Illinois Power Company
500 South 2nd Street
P.O. Box 511
Decatur, IL 62525-1805

July 15, 1992

Clinton Power Station
Request to Modify NPDES Permit IL0036919

P&ID SHUTDOWN SERVICE
WATER (SX)
CLINTON POWER STATION
UNIT 1
ILLINOIS POWER COMPANY
CLINTON, ILLINOIS

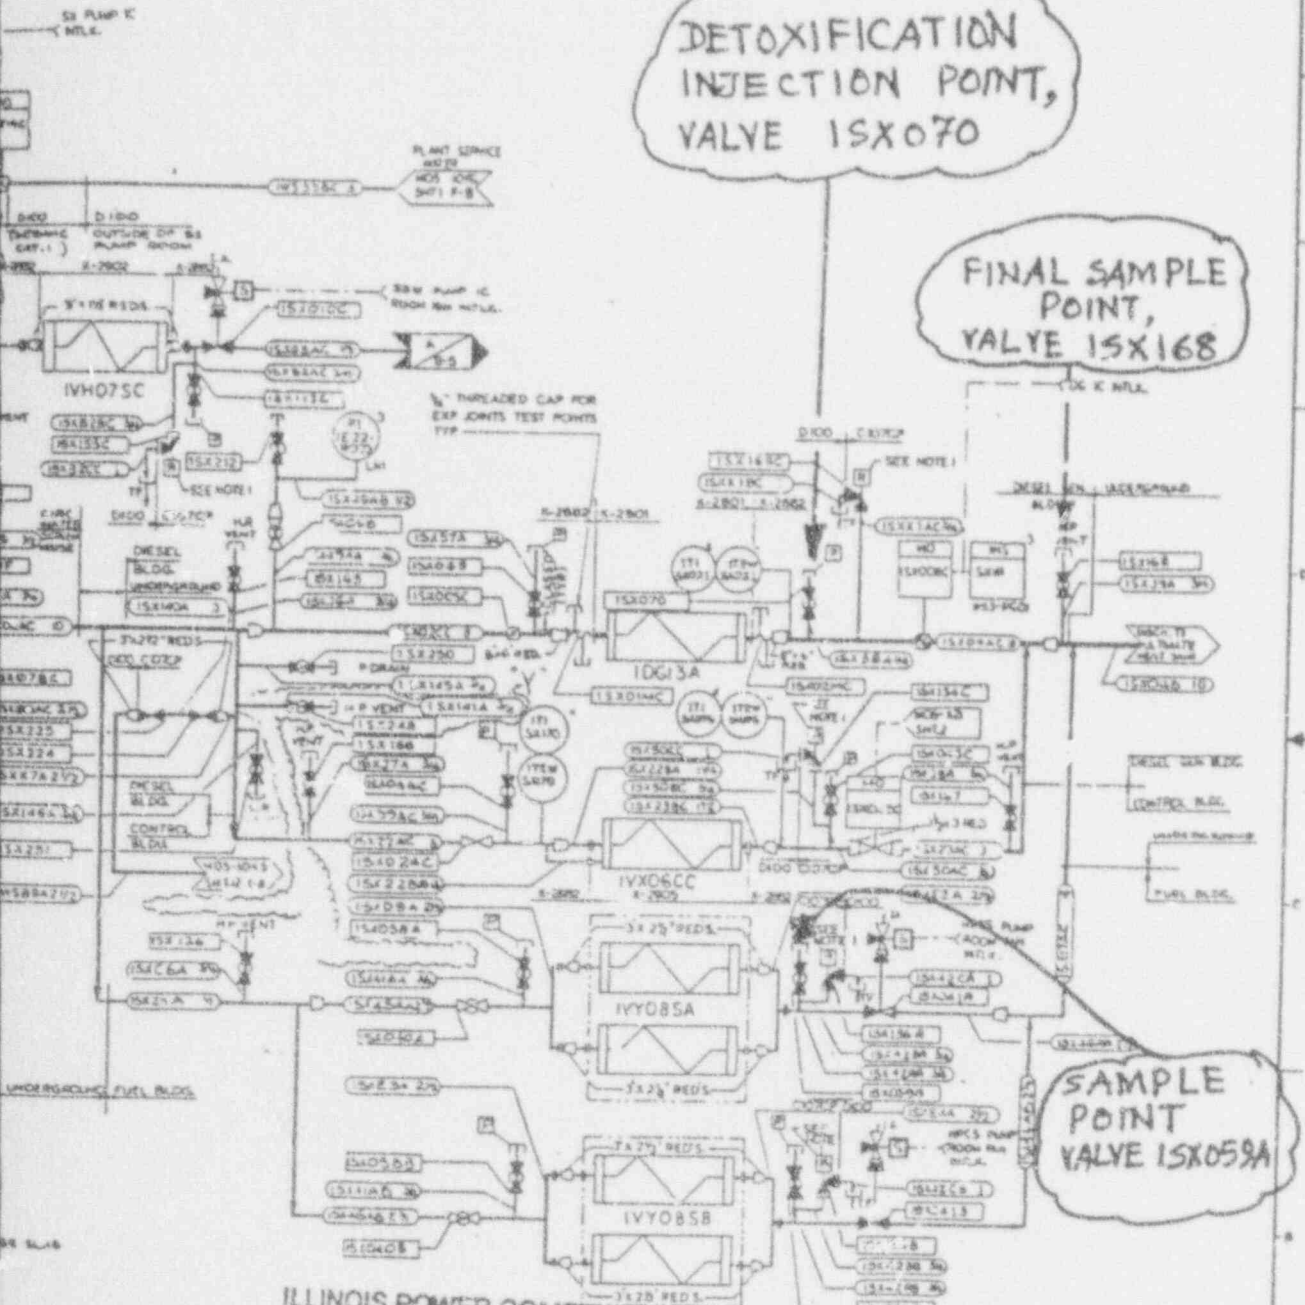
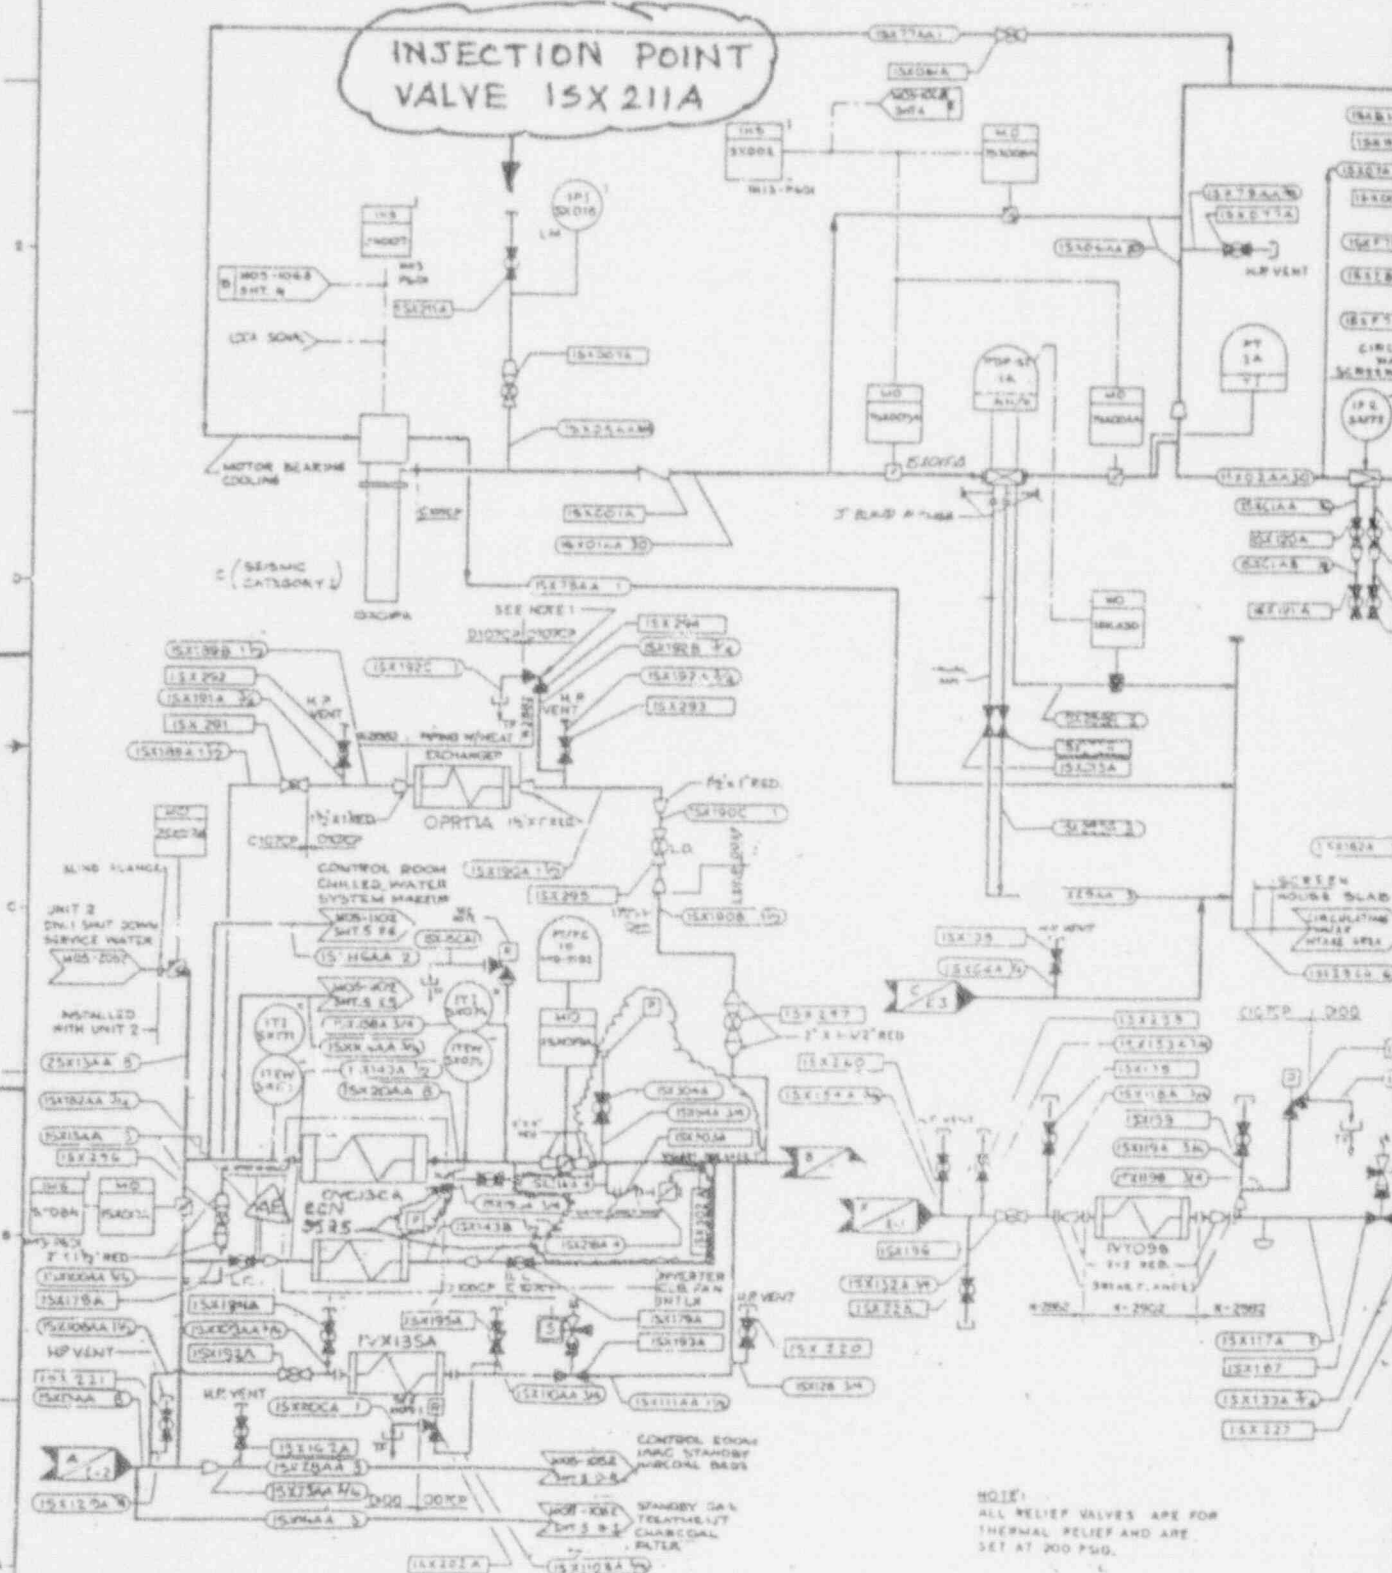
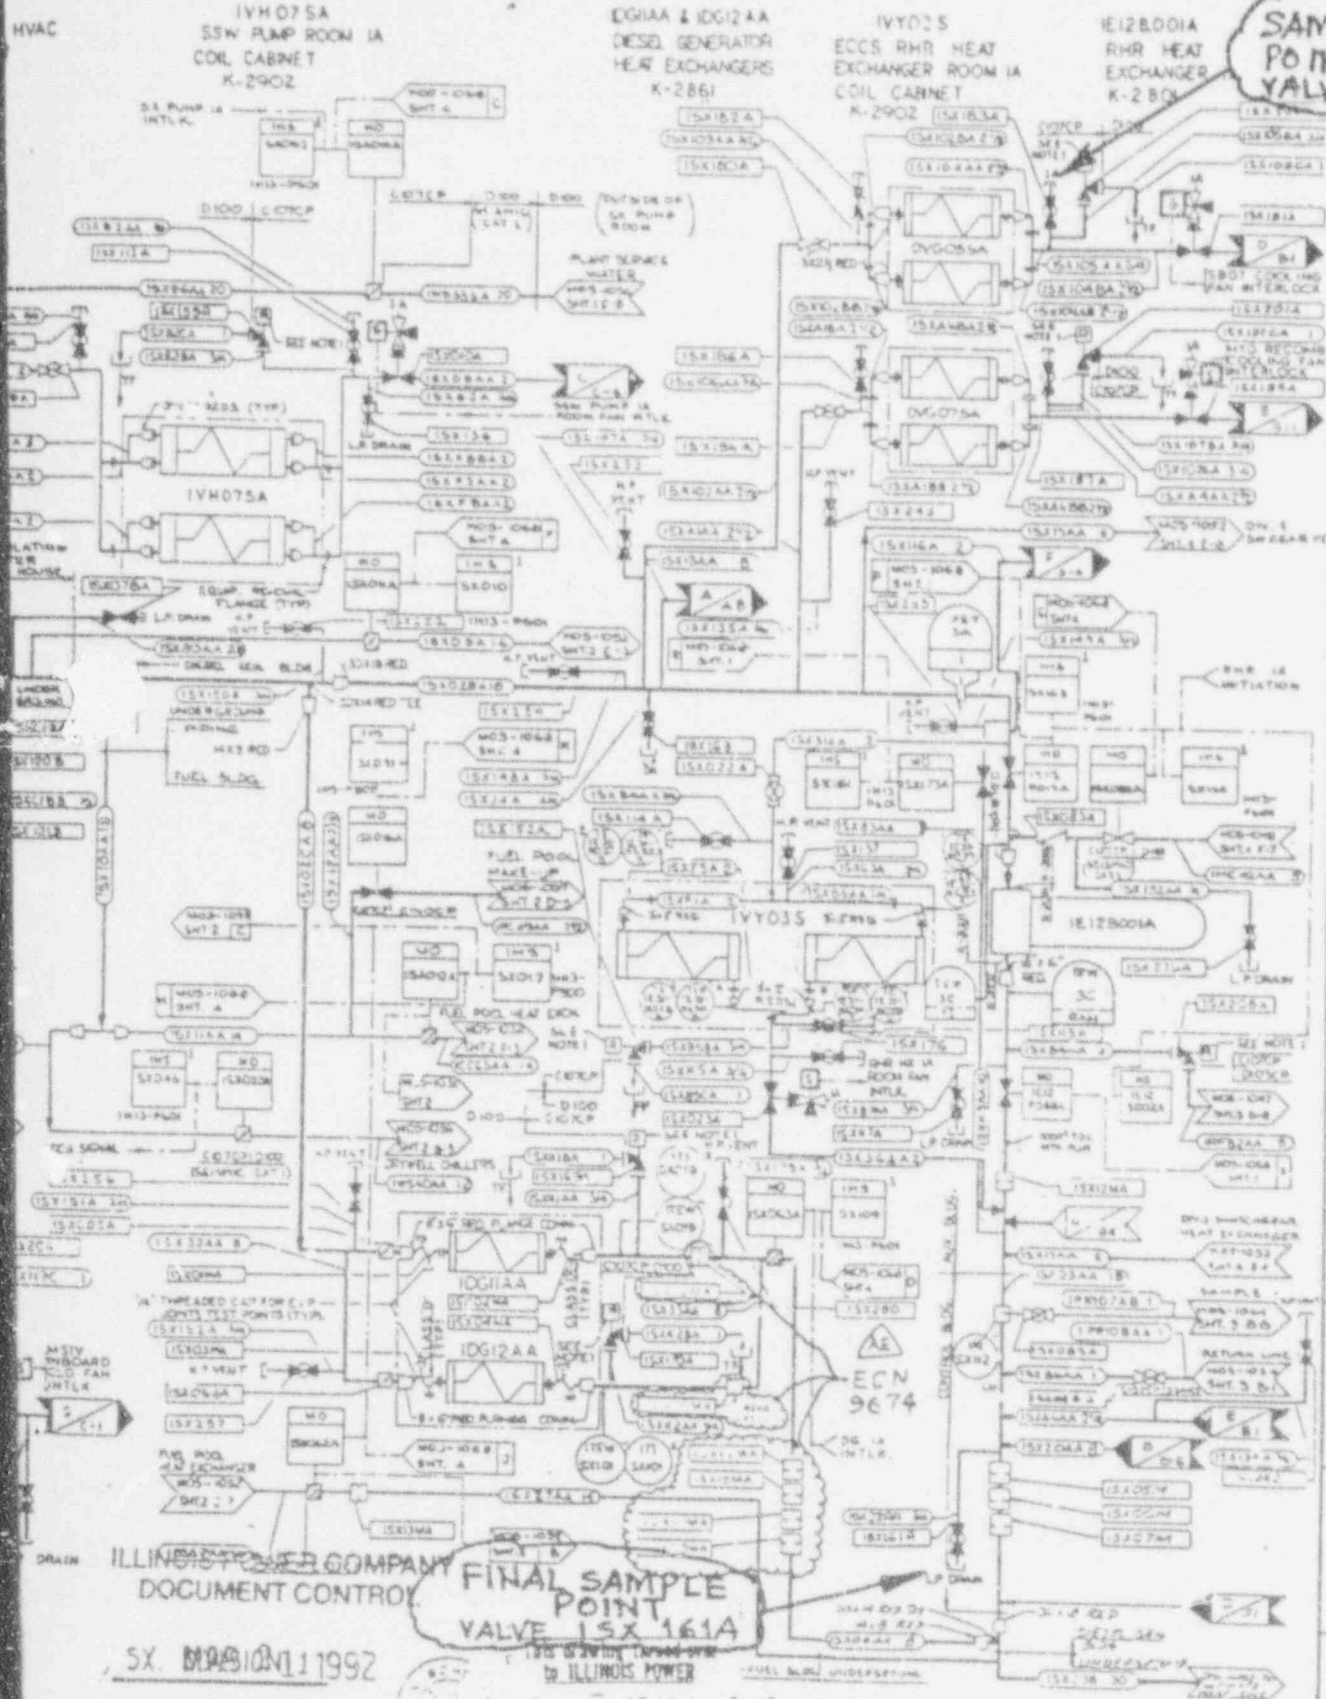
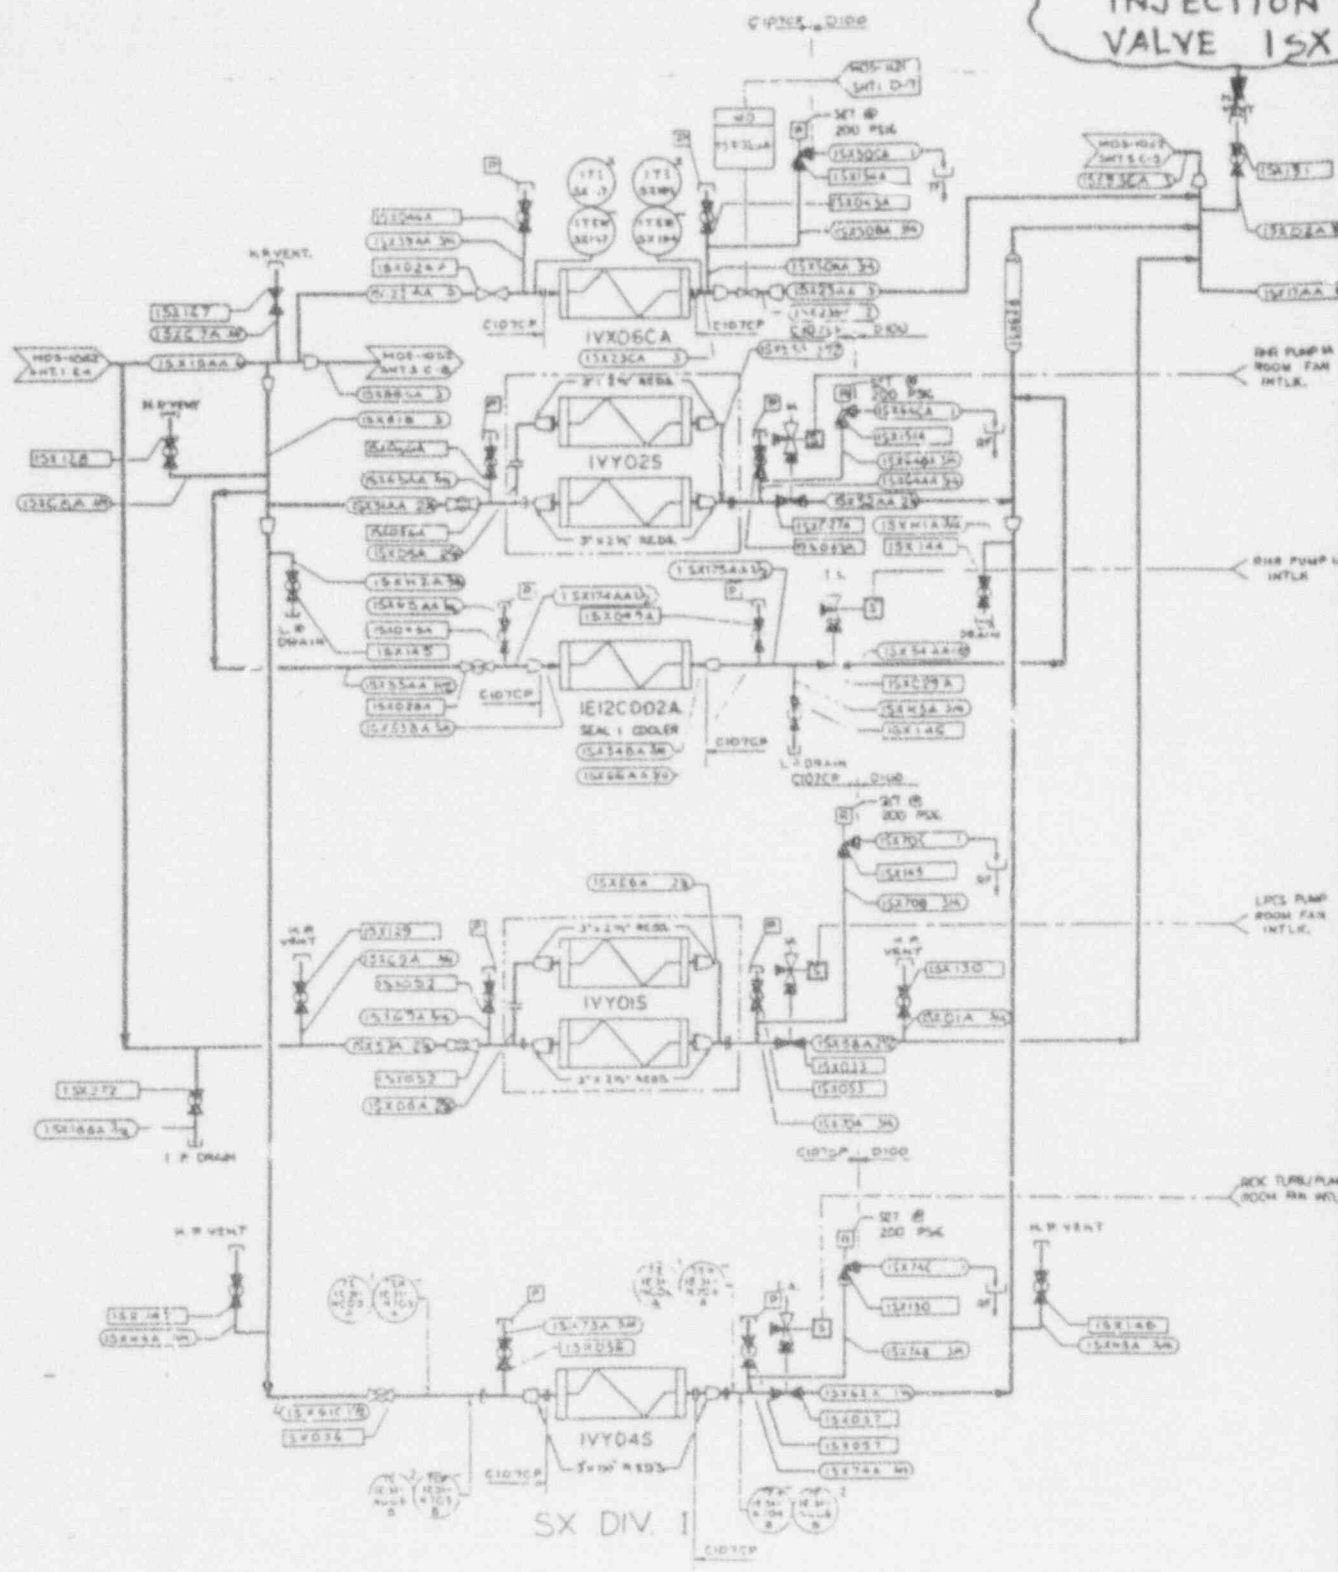
- (g) IP also wishes to notify the Agency of changes in the chemical injection and monitoring points for the SX system treatment program. The exact locations of these points are shown on the enclosed four figures.

DETOXIFICATION
INJECTION POINT,
VALVE 1SX070

FINAL SAMPLE
POINT,
VALVE 1SX168

SAMPLE
POINT
VALVE 1SX059A

INJECTION POINT VALVE 15X211A

SAMPLE POINT VALVE 1SX183A

FINAL SAMPLE VALVE 1SX161A

SAMPLE POINT
VALVE 15X183B

DETOXIFICATION
INJECTION
POINT
VALVE 15X124
